MAAP 3.0B/BWR REVIEW
Technical Evaluation Report 3
Severe Accident Containment Modeling

*Safety and Risk Evaluation Division
Department of Nuclear Energy
Brookhaven National Laboratory
Upton, New York 11973*

October 1990

MAAP 3.0B/PWR REVIEW
Part 3: Containment Response

Figure III Two Phase Construction for Mixture

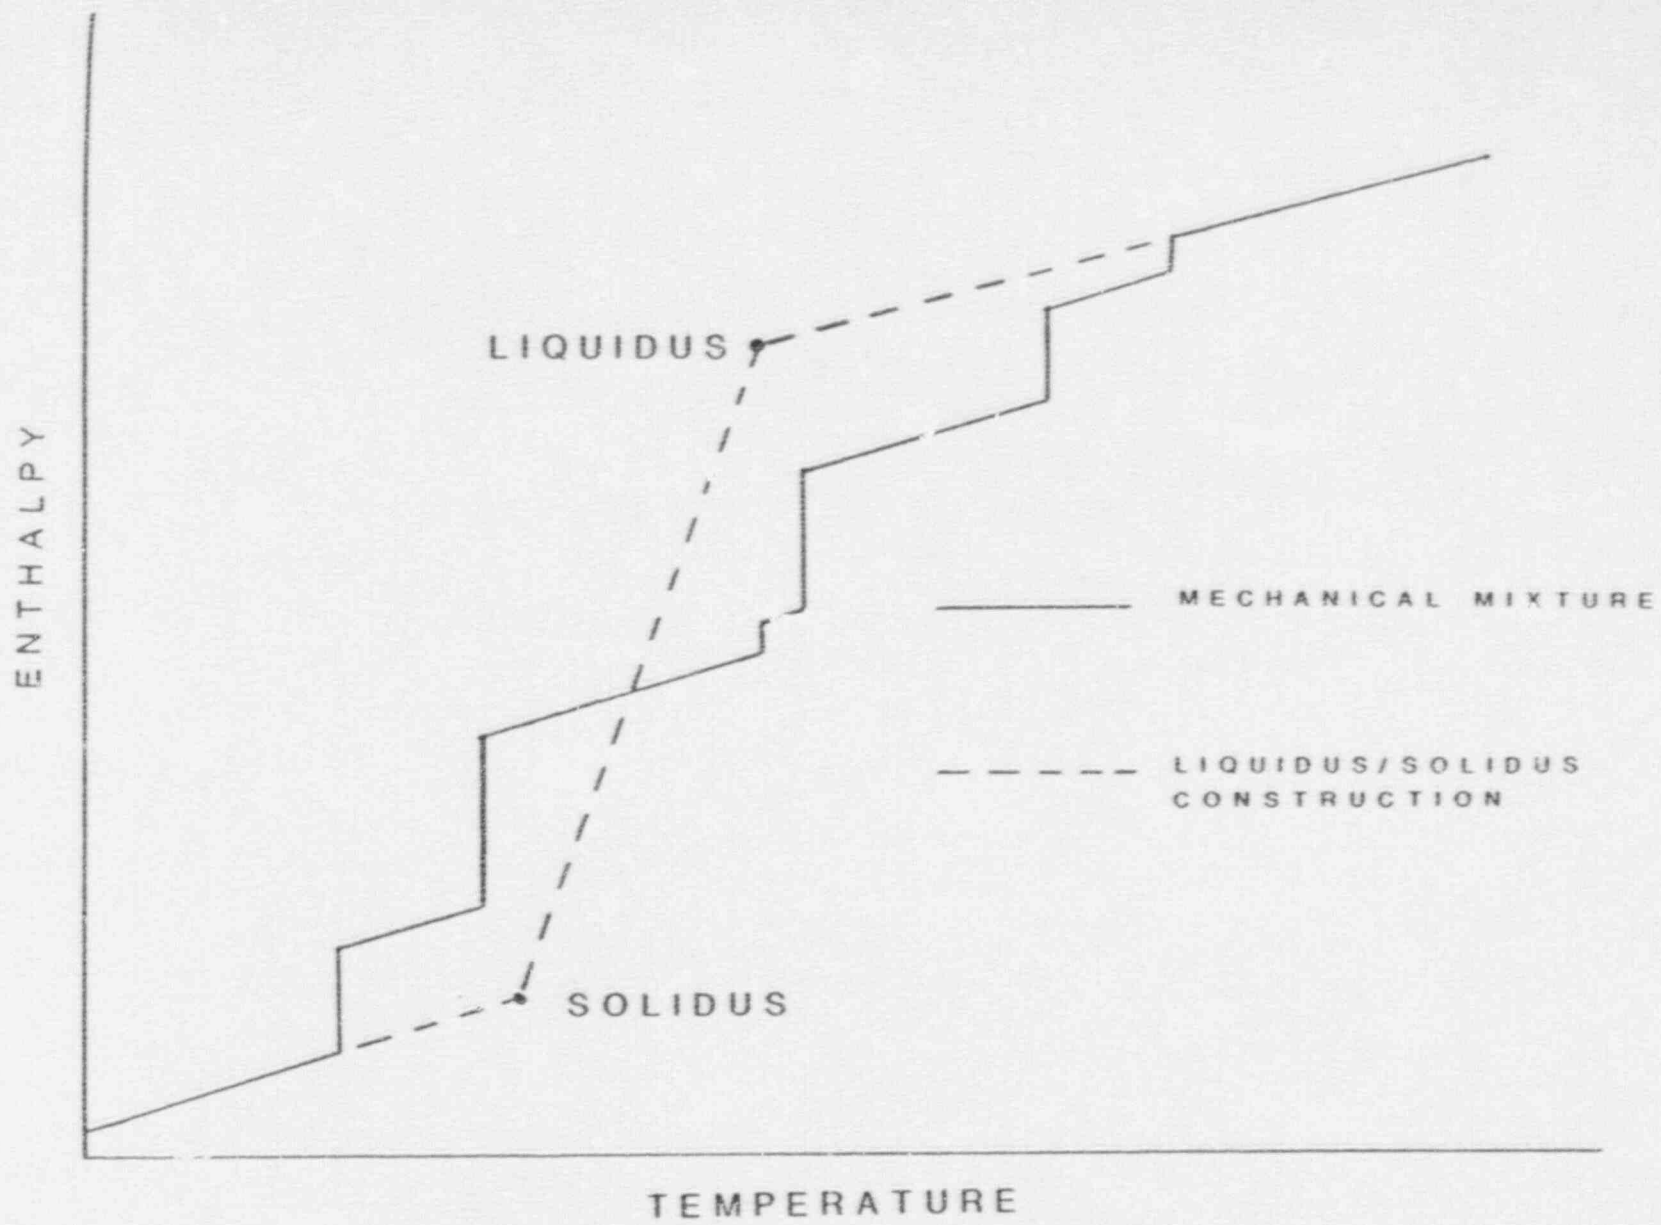
MELCOR has a range of melting temperatures for each layer or mixture. At temperatures below the solidus and above the liquidus, each layer has its enthalpy or internal energy weighted by the material composition. However, between the liquidus and solidus temperature, a linear extrapolation of enthalpy is used (see Figure 3). As a means of comparison MAAP utilizes a mechanical mixture model as shown in this figure.

Neither model is exact. The presence of such a large mixture of elements is sure to produce quite a complicated phase diagram (map). This effects the containment analysis in how the debris pool energy is allocated. Whether this will be in increasing the atmospheric temperature of the containment, ablating concrete or being retained to produce a phase change is the significant figure of merit.

Figure IV H₂-Air-H₂O Ignition Example

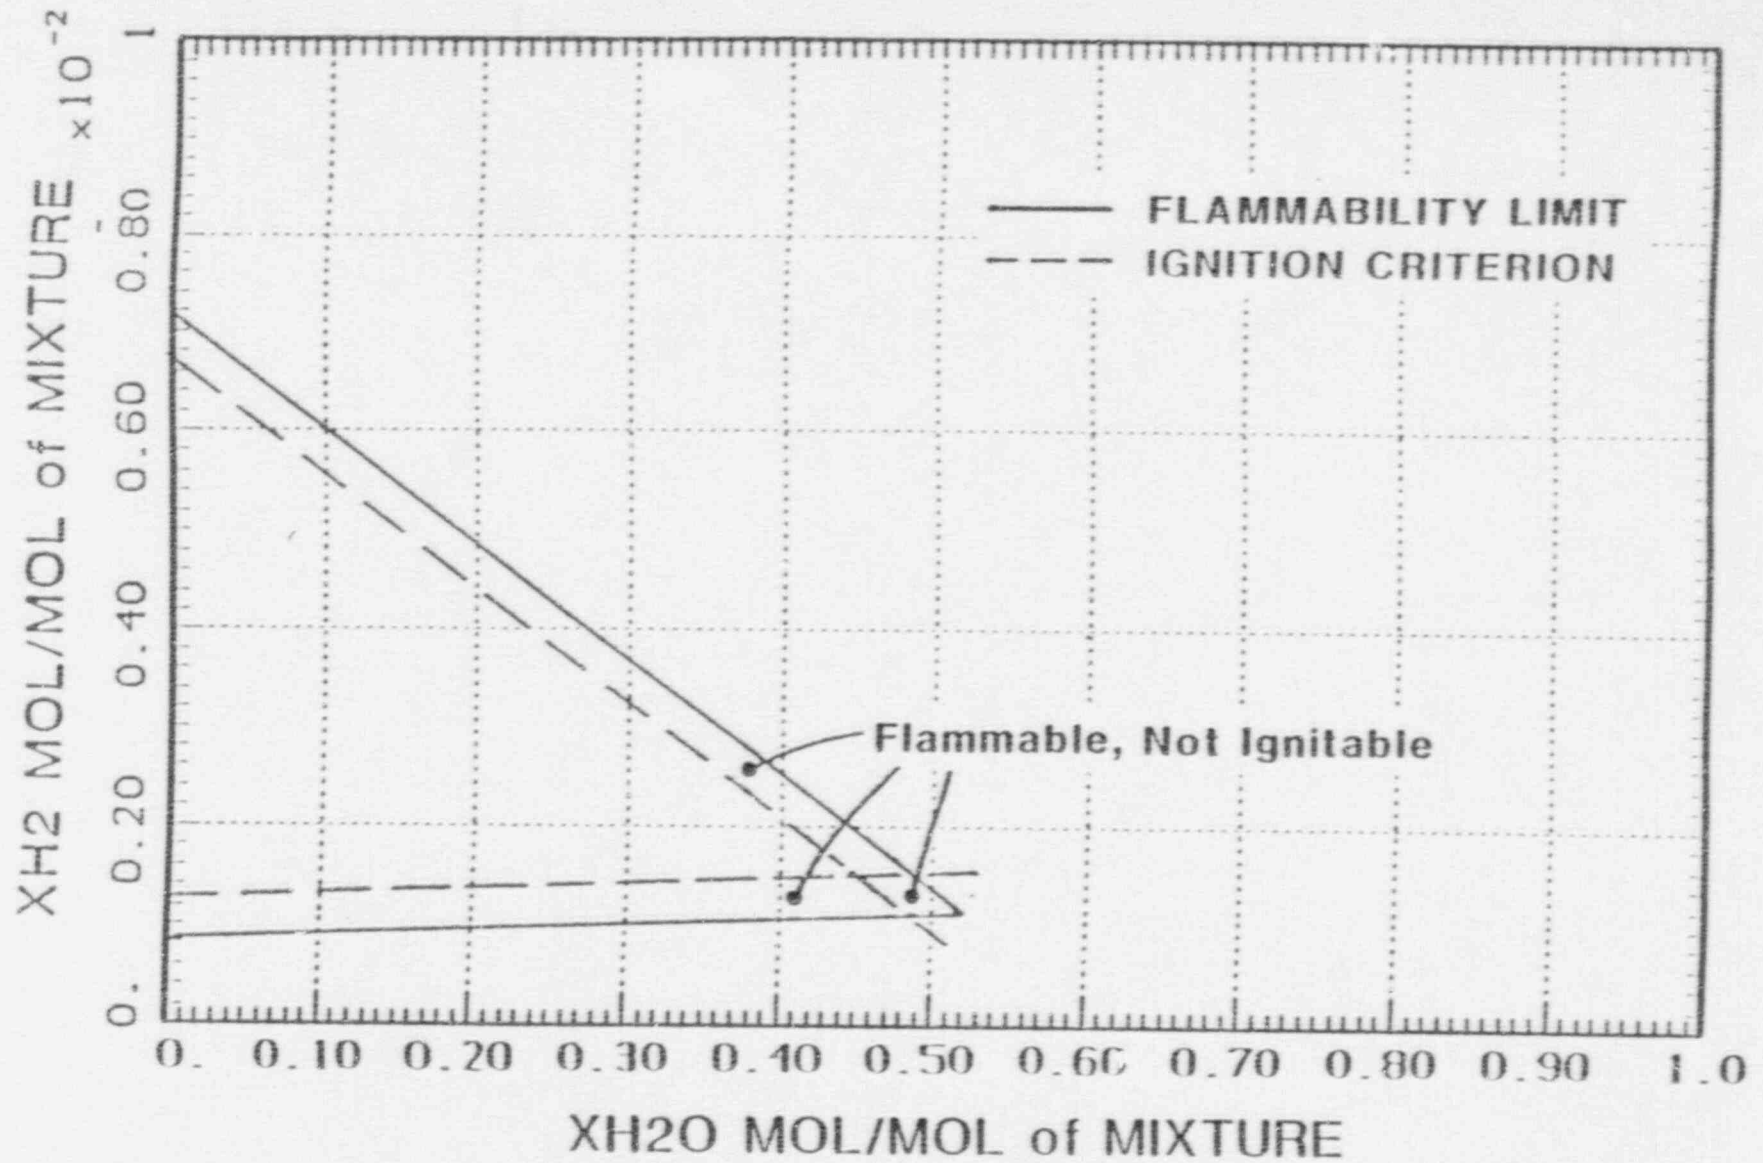
rise in temperature has the effect of increasing the (combustible mixture) range for flammability. The determination of ignition is based on a user supplied offset of the LFL and RFL. Thereby reducing the acceptable mixture required to a subset of the flammability regime. Figure IV gives an example of the LFL, RFL and the ignition offset.

It can be seen that MAAP's model is more sophisticated than MELCOR's. Modelers of IPE's must be careful not always to assume combustion close to the LFL, assuming this to be conservative. One could get a greater pressure increase if the ignition was not allowed until the RFL was reached.

Figure 5.1 MAAP Predicted Flame Speed

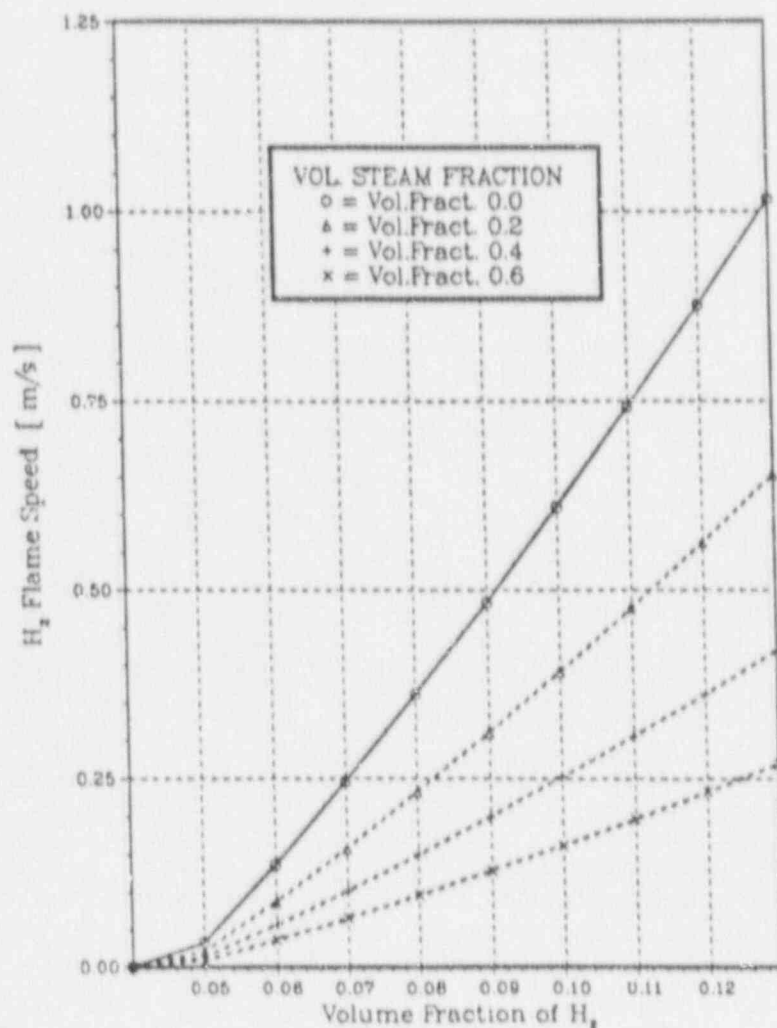
The flame speed correlation used in MAAP is a function of the initial molar fraction of combustible gases (H_2 and CO), the initial molar fraction of diluents (steam and CO_2) and temperature. A graphic presentation of the flame speed at $100^\circ C$ is given in Figure 5.1.
